## SUBMITTAL RESPONSE

PROJECT NAME : PSE OTC

Item :	Joist & Metal Deck Shop Drawings
--------	----------------------------------

**PSE TRAINING CENTER PUYALLUP**  
 PUYALLUP, WA  
 PENNON CONSTRUCTION COMPANY INC.  
 GENERAL CONTRACTOR  
 SEI JOB NO: 43423

**1 LEVEL 01 - SHEETMETAL**  
SCALE: 1" = 10'-0"

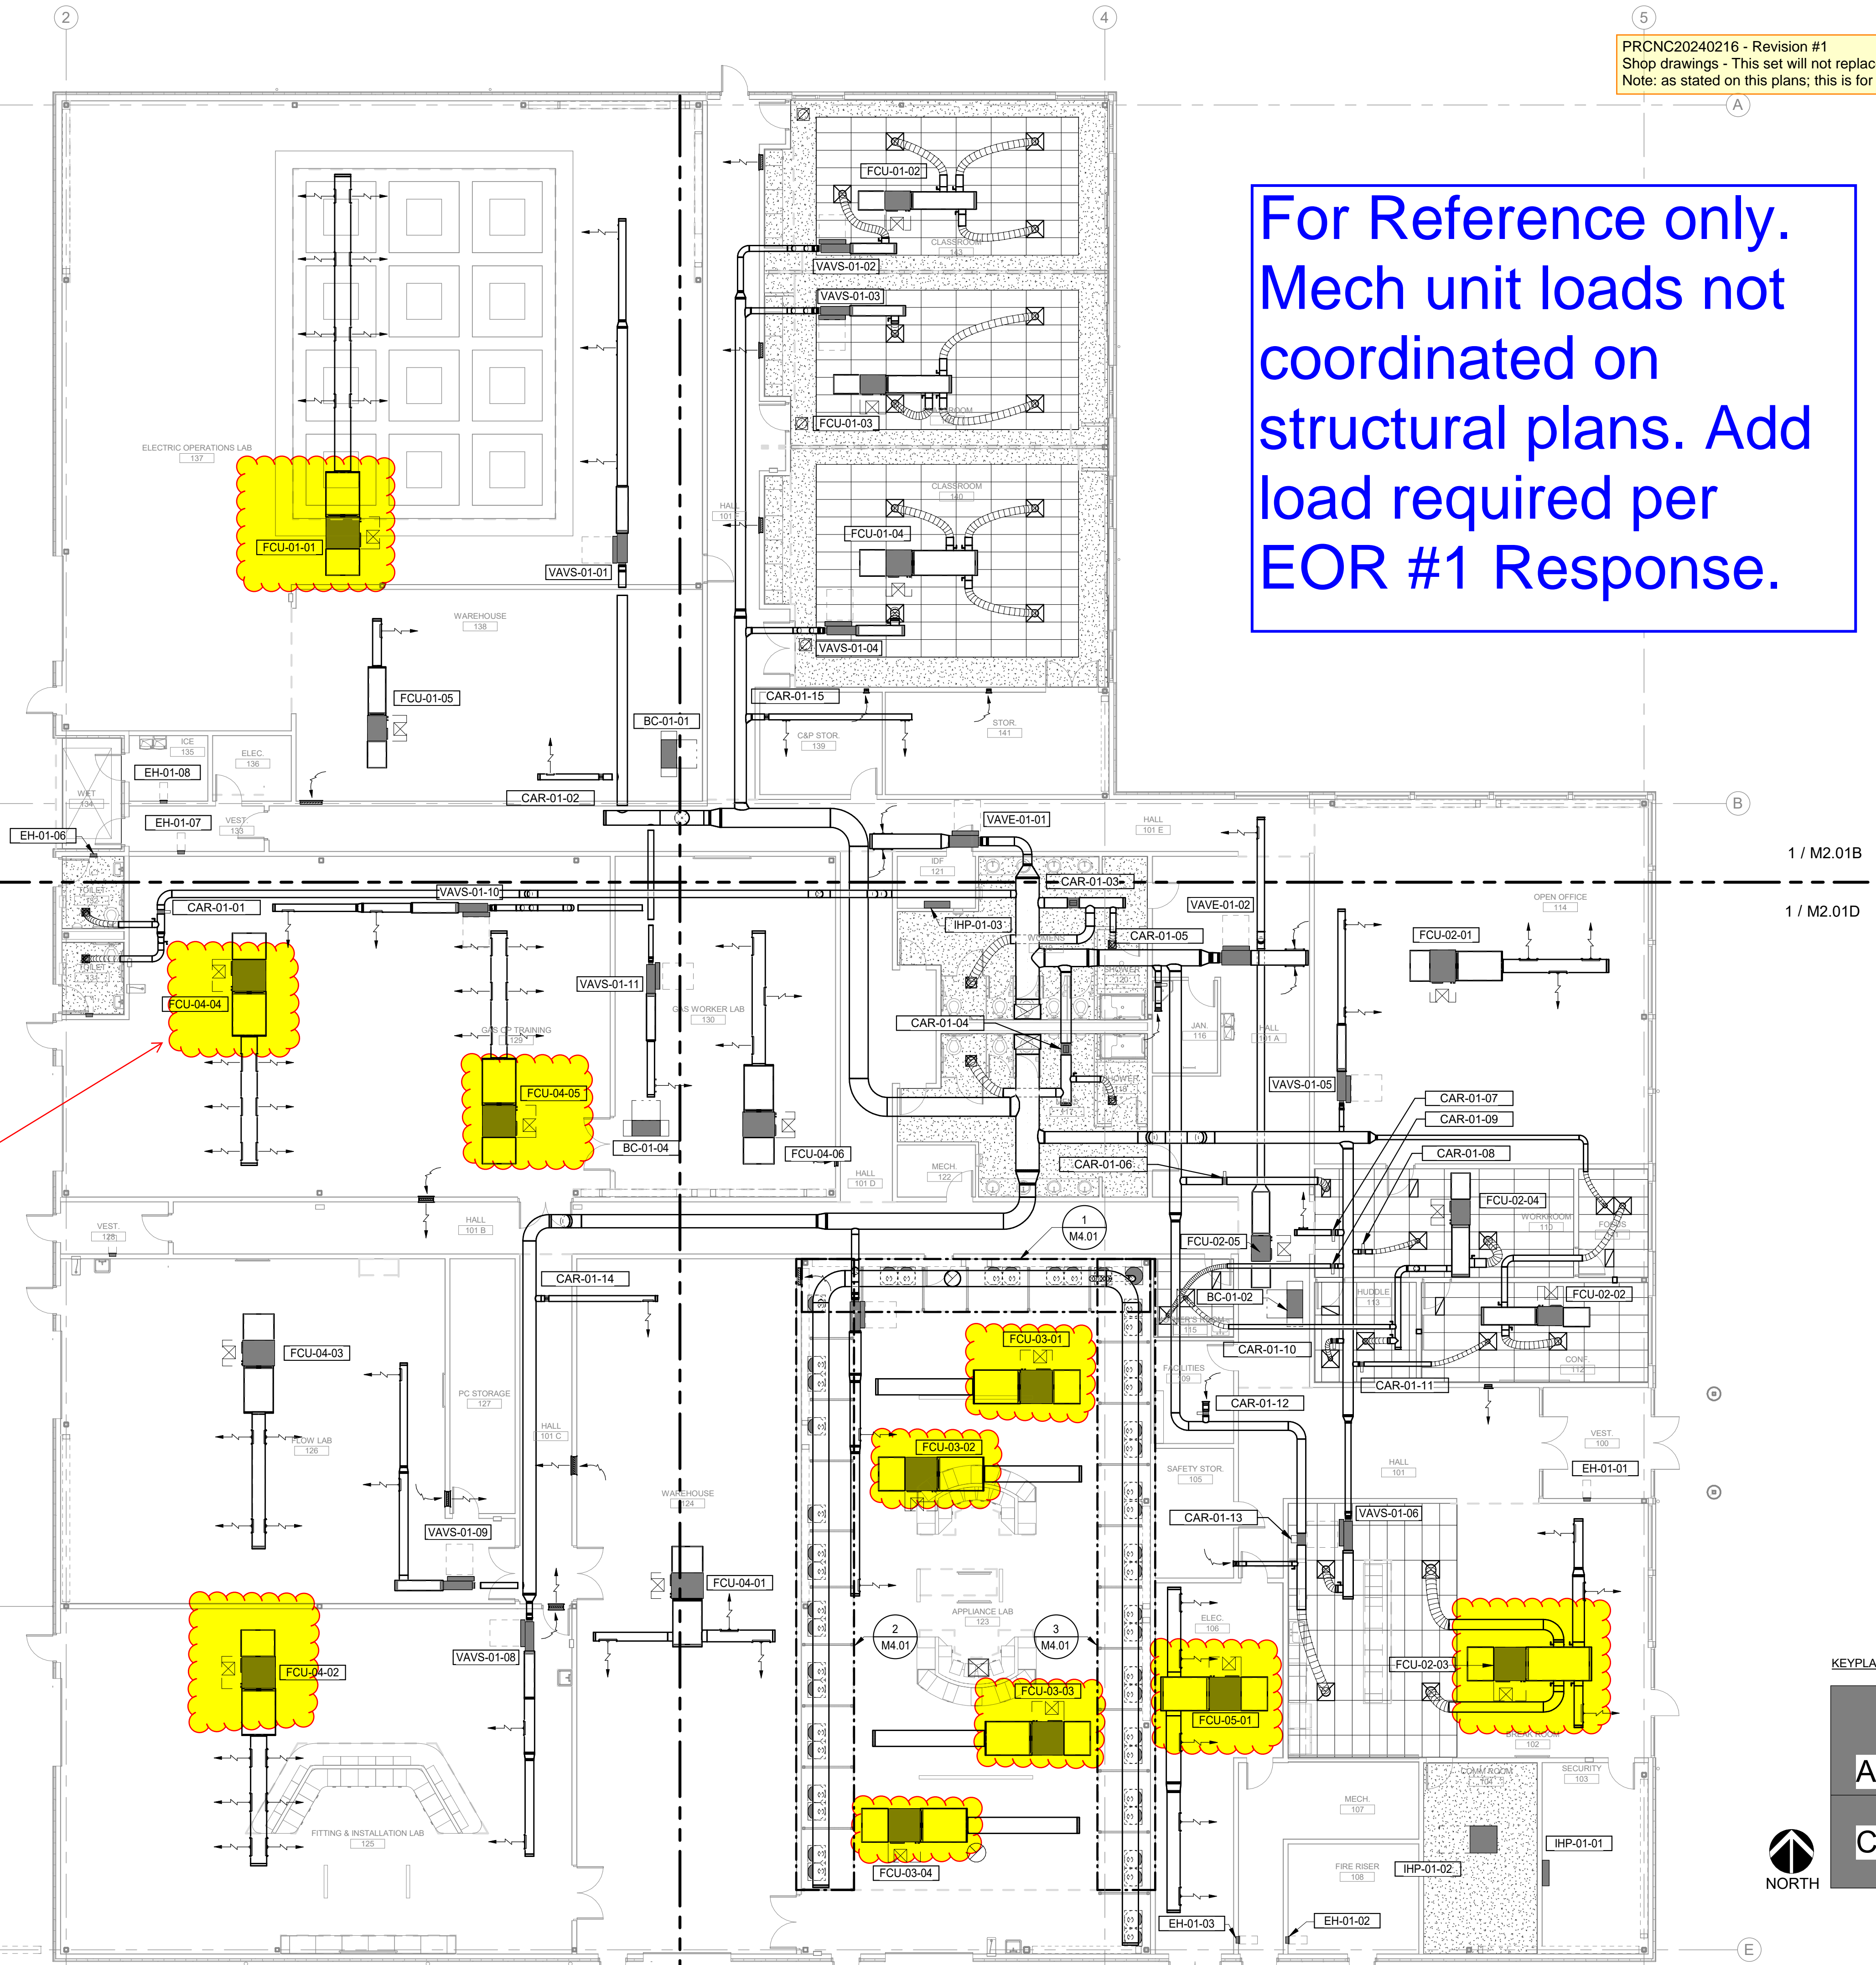
For Reference only.  
Mech unit loads not  
coordinated on  
structural plans. Add  
load required per  
EOR #1 Response.

Add Load of 220lbs at  
highlighted locations
